Subject: **Bid #: 7946-W3, Green Hill Park Community Garden / DPWP**

### **ADDENDUM NO. 2**

**Project:** Bid No. 7946-W3 **Greenhill Park Community Garden**  
**City of Worcester Department of Public Works and Parks**  
**Parks, Recreation and Cemetery Division**

**General Bid Clarification**

**E1.01**

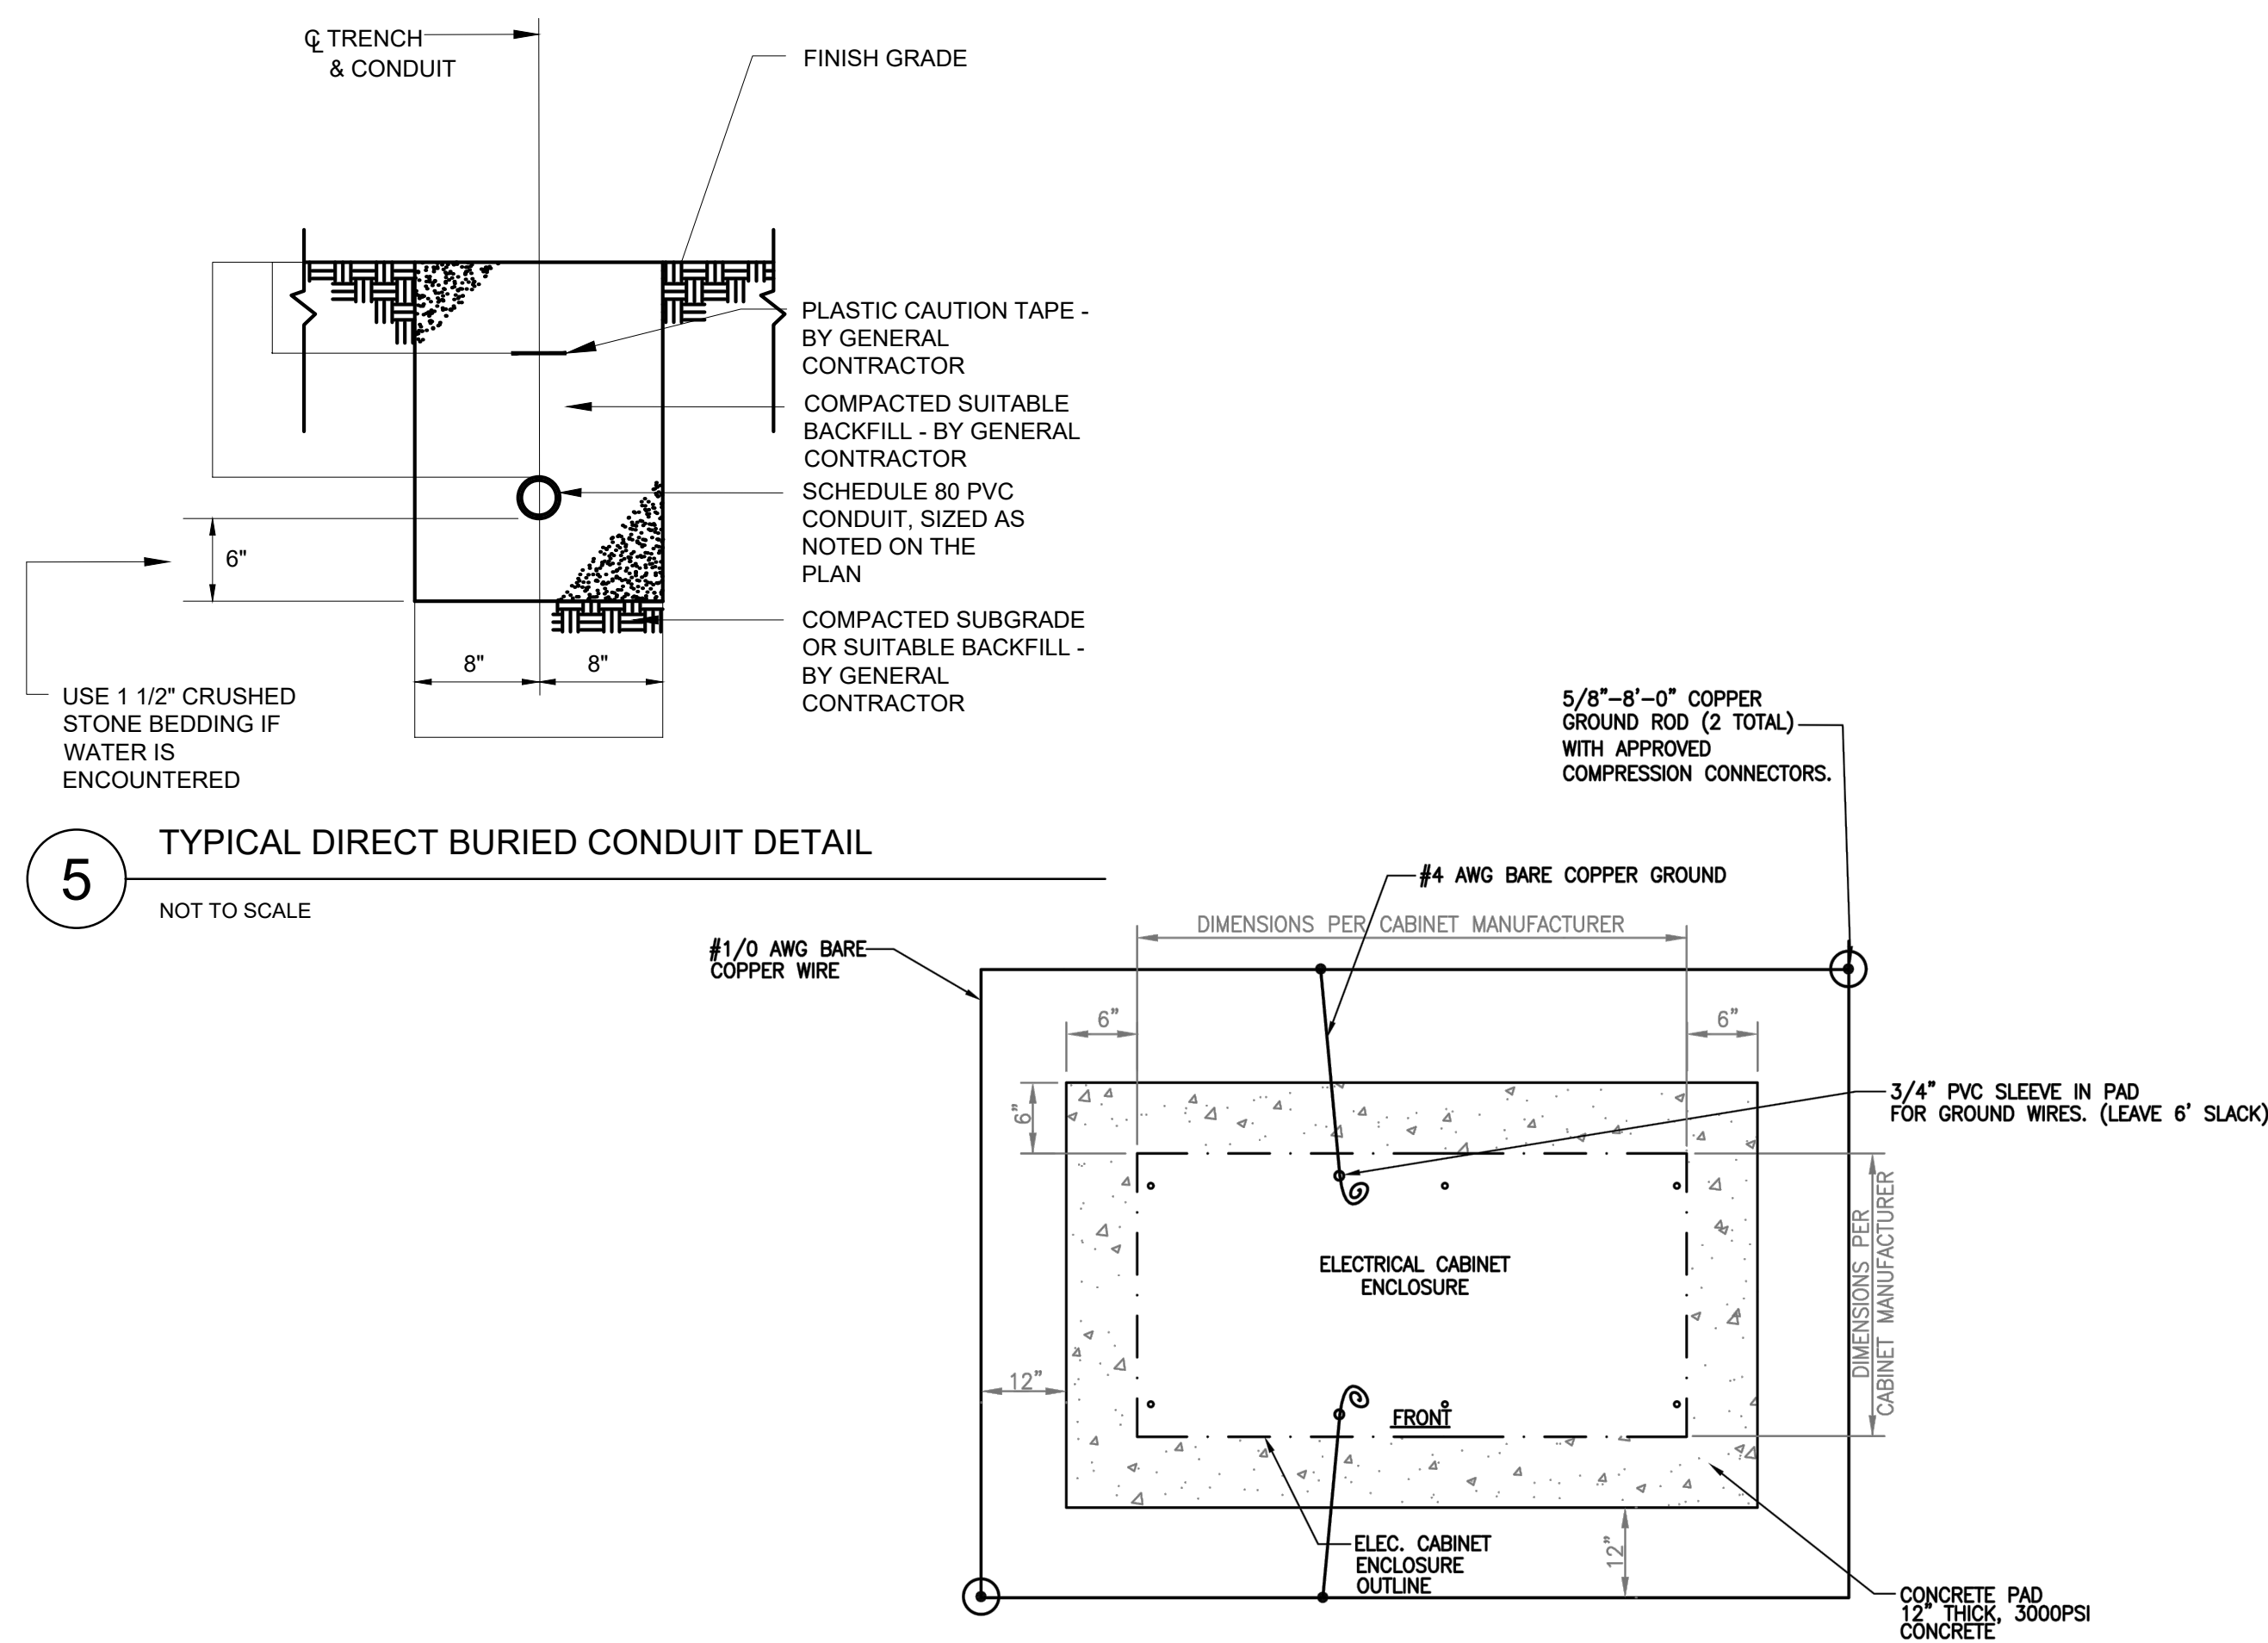
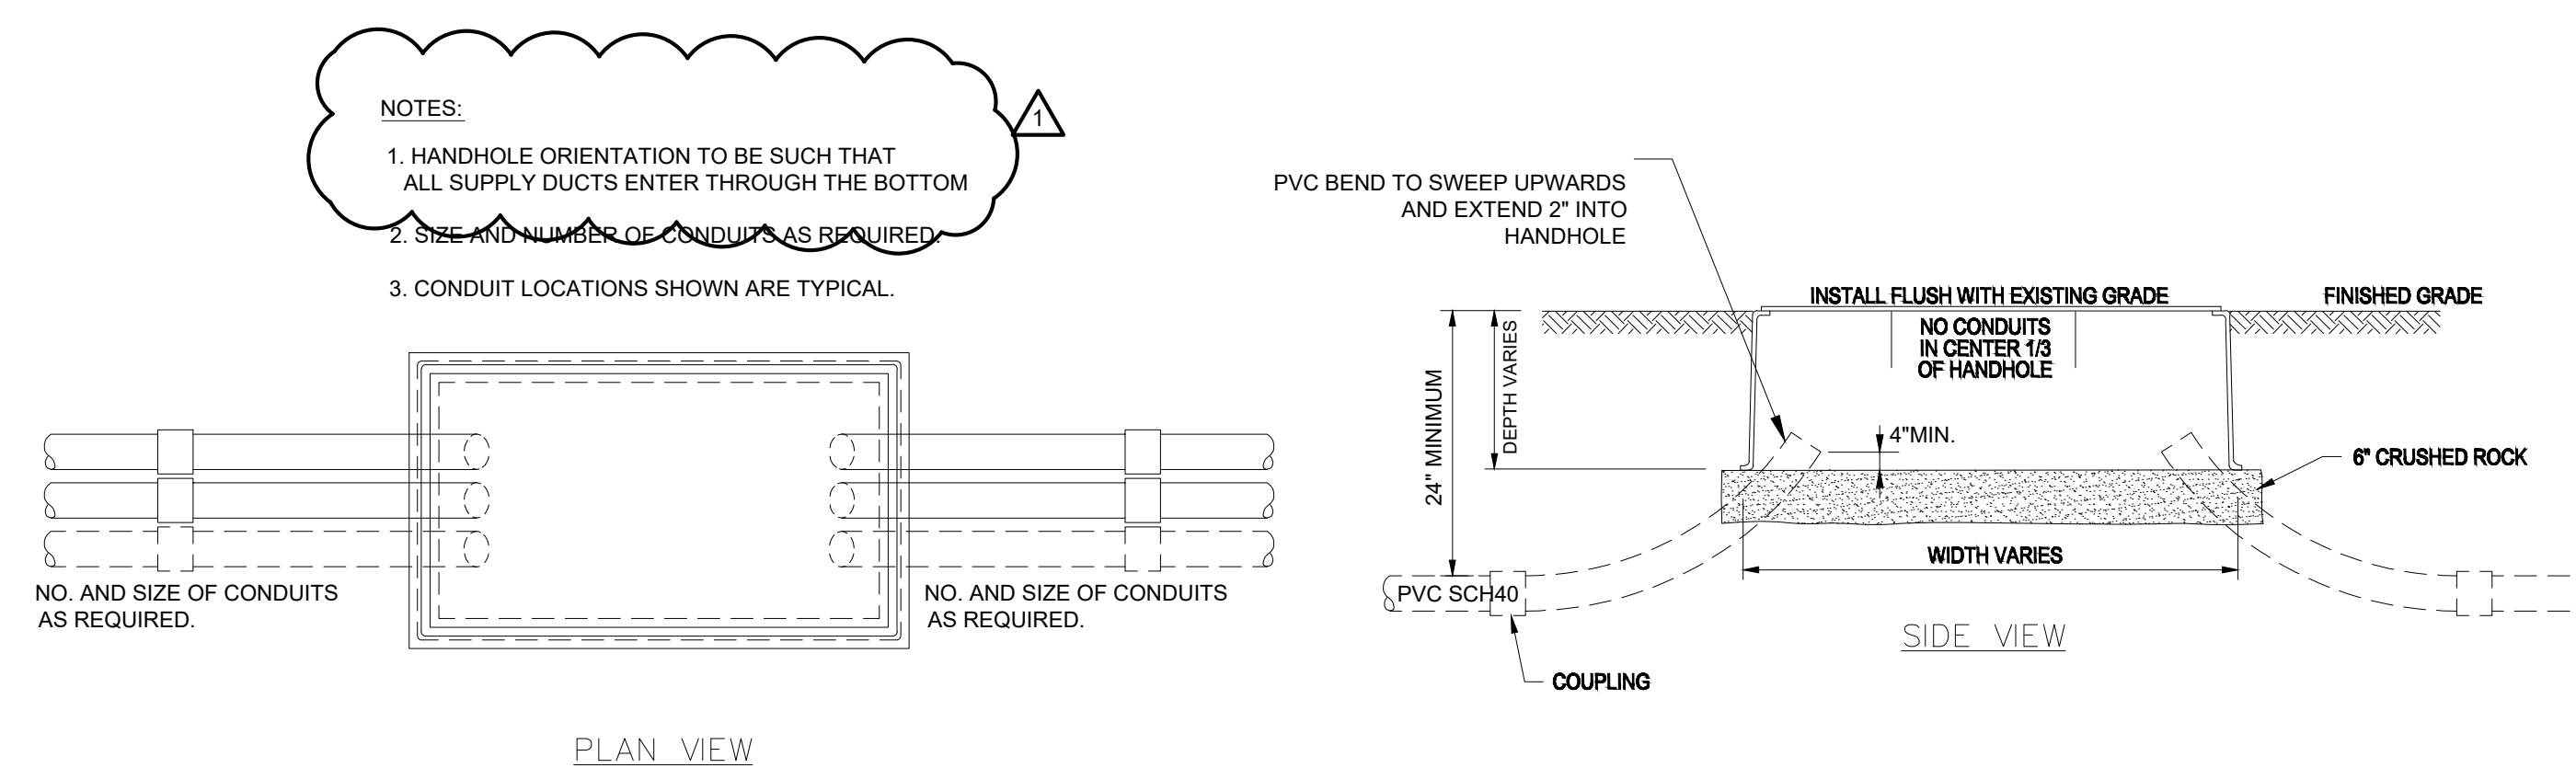
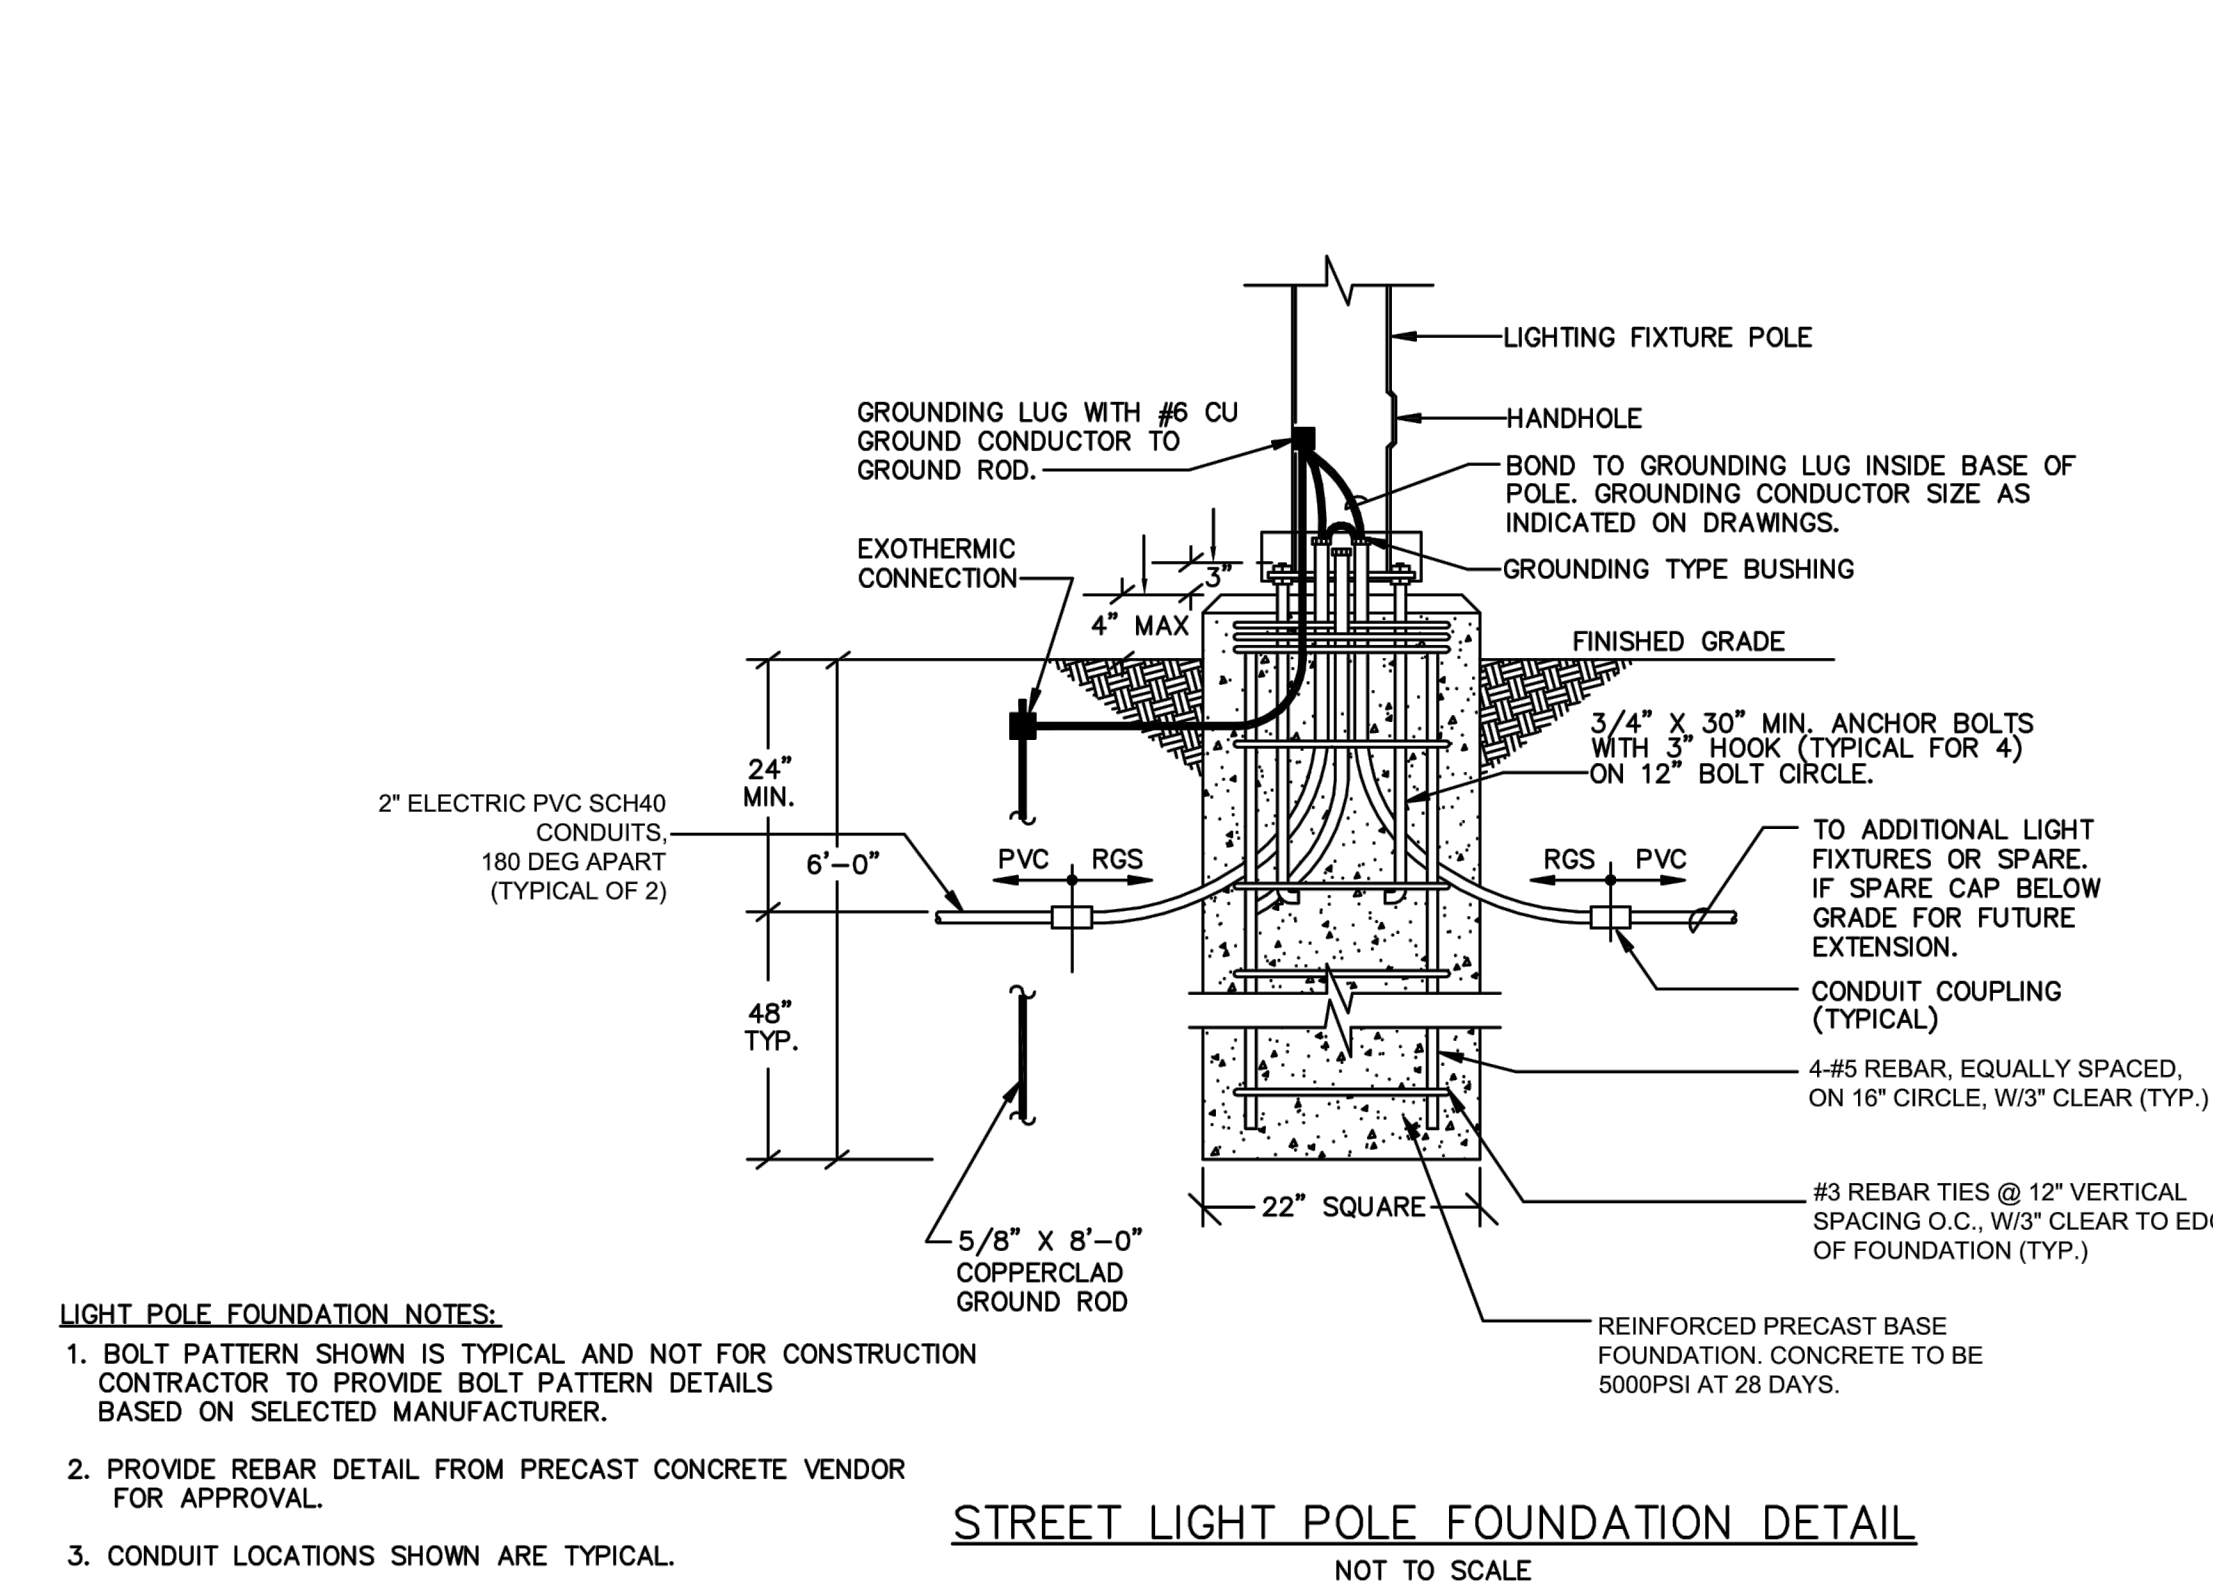
Question 15: The Electrical Plan on Sheet E1.01 shows 5 light poles that are not connected into the communication duct bank. Please confirm that not all light poles need to be connected to the communication duct bank.

**Answer 15:** Communications is required only at light poles as shown on the drawings.
